TO: Water Rights Section Oct 9, 2000  
199  
 FROM: Groundwater/Hydrology Section Ivan Gall  
 SUBJECT: Application G- 15192 Reviewer's Name

**Proposed Permit Conditions: Application G-15192**

**Date:** October 5, 2000  
**To:** Groundwater/Hydrology  
**From:** Ivan Gall – Grants Pass  
**Subject:** GW Application G-15192

Recovery Data, Pumping Well, JOSE 1979/JOSE 12820  
Robert & Susan Smallwood Aquifer Test, G-15192

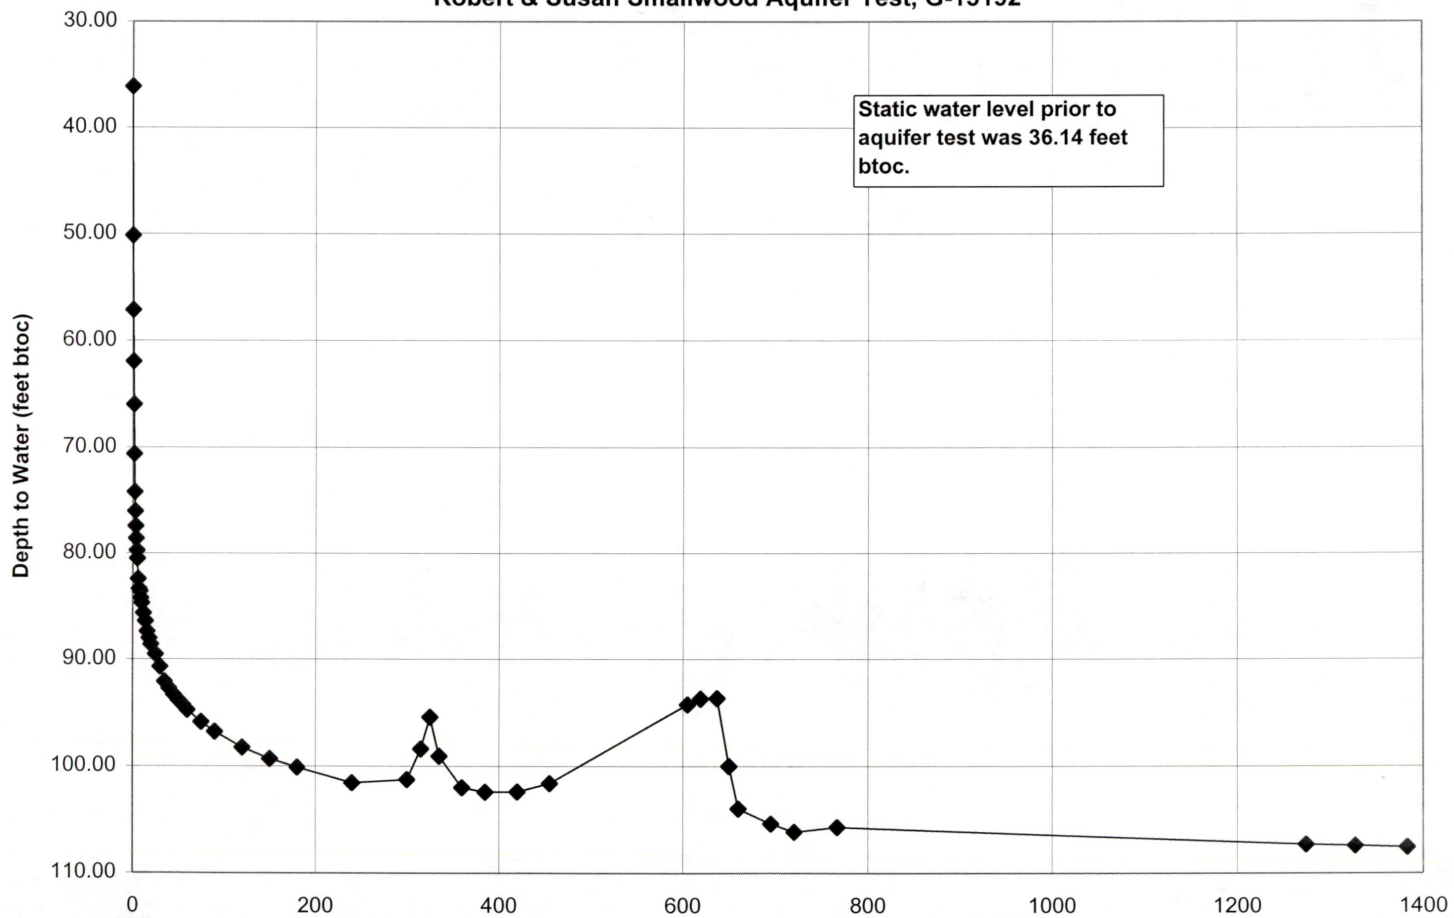
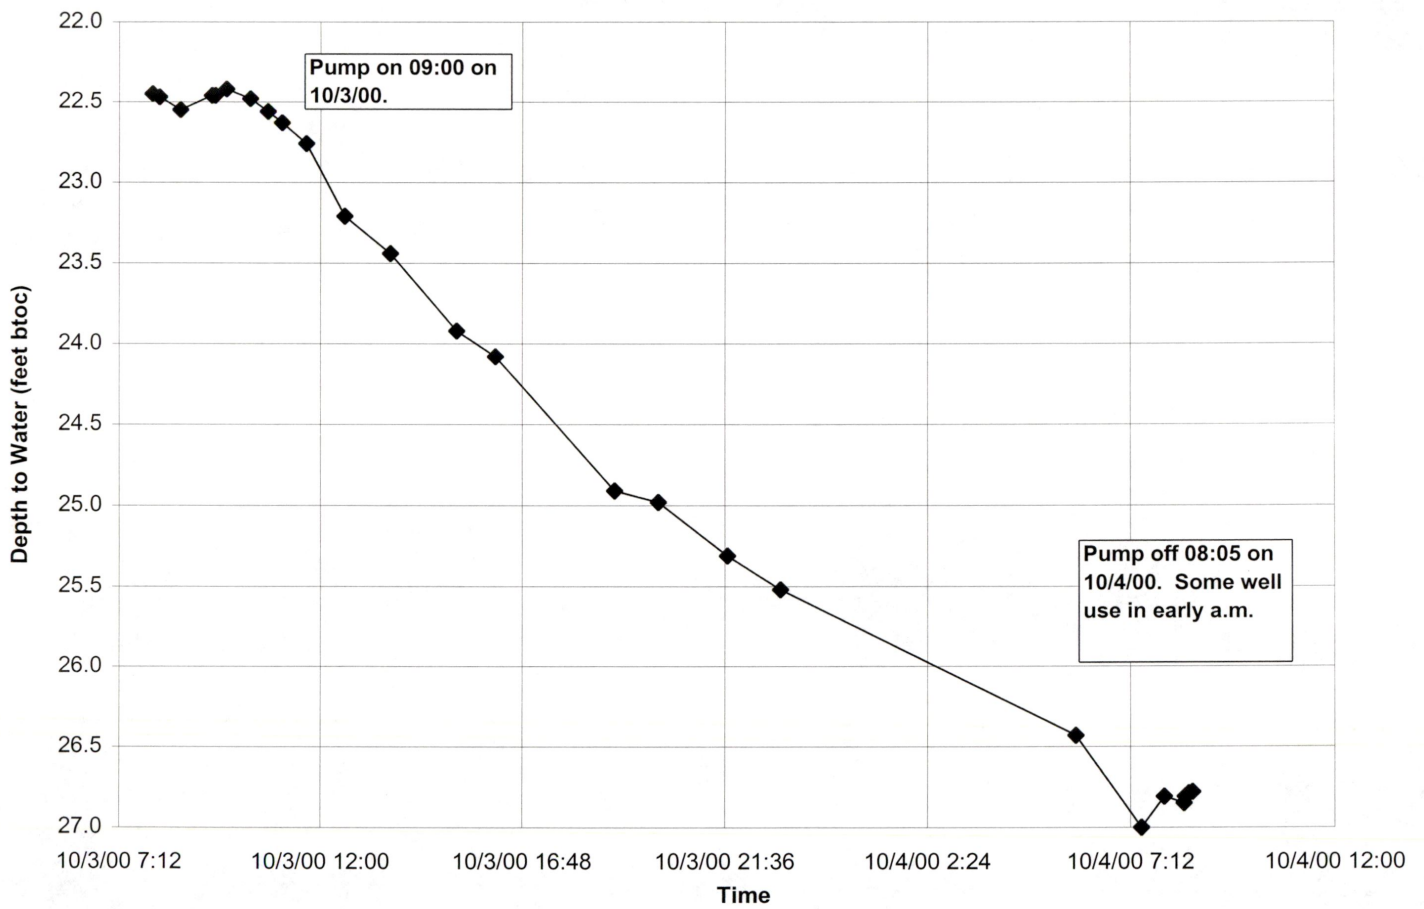
Following cessation of pumping, recovery water level data was collected from wells #1 and #2. Well use at well #1 interrupted recovery data collection at this well. Plots of recovery data for well #2 are also provided. Data indicate that the water level in well #2 was nearly fully recovered after 22.5 hours of recovery.

Pumping Well, JOSE 1979/JOSE 12820  
Robert & Susan Smallwood Aquifer Test, G-15192

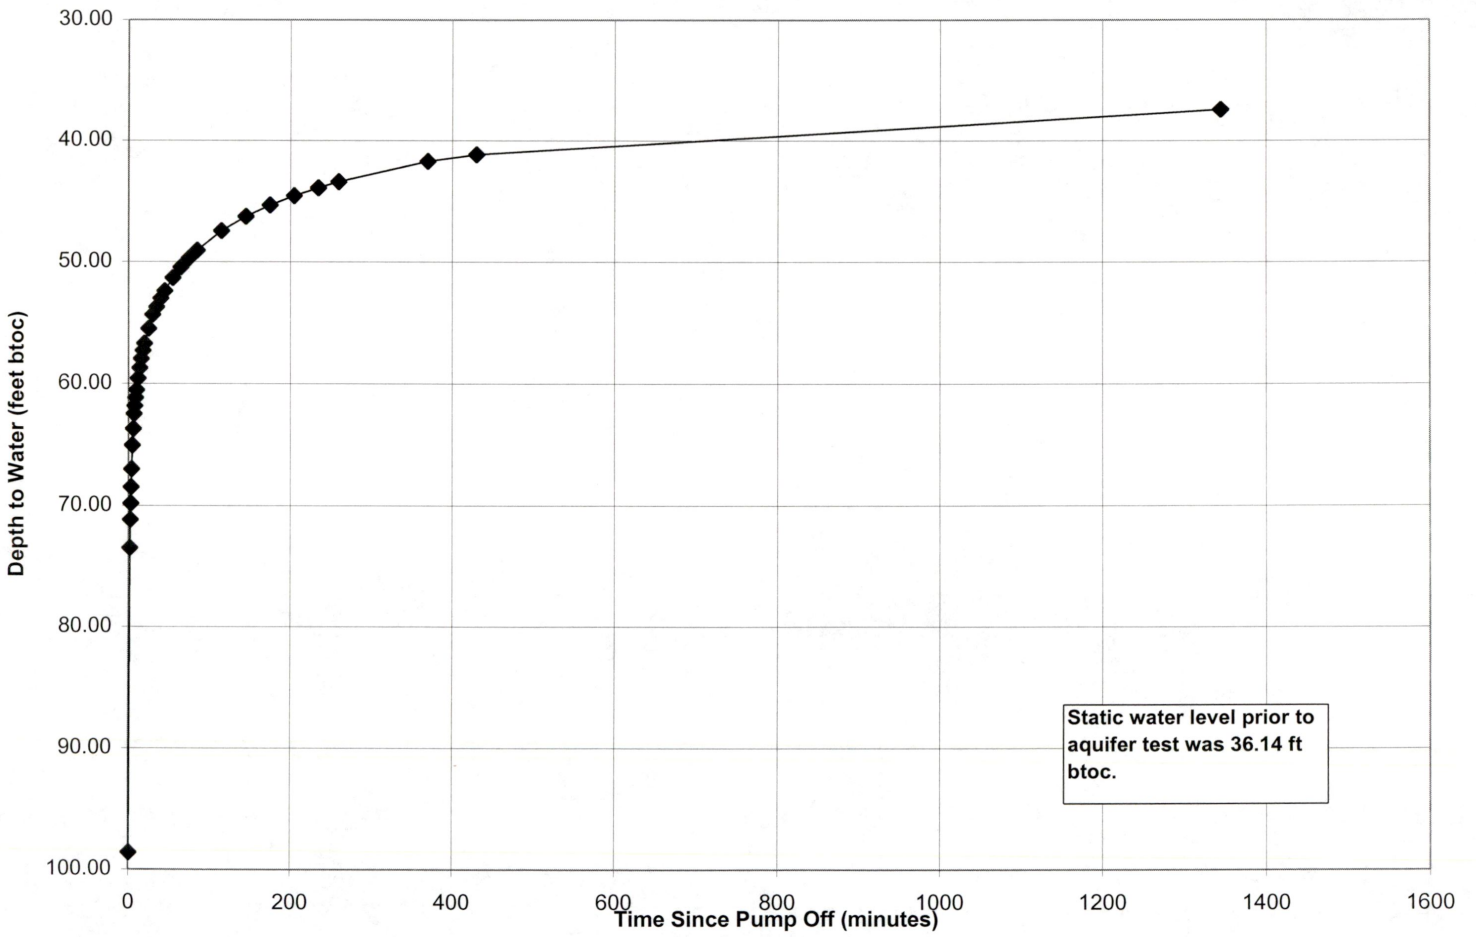
unknown, but likely having to do with the generator's power output. The generator was shut off for 2-3 minutes several times during the test for refueling, and this seemed to bring the discharge rate back to 61-62 gpm. Note the water level fluctuations on the pumping data plots (attached).

Prior to the pumping of well #2, the static level's of the wells were 43.13 feet (Bauer well), 22.47 feet (well #1), and 36.14 feet (well #2). No significant drawdown was observed at the Bauer well following 23 hours of pumping at well #2. One-tenth of one foot of drawdown may have occurred, but due to sparse measurements late in the test, direct correlation with pumping could not be made. Well #1, the Smallwood domestic well 390 feet NE of the pumping well, had approximately 4 feet of drawdown following 23 hours of pumping. The pumping well had approximately 71.4 feet of drawdown.
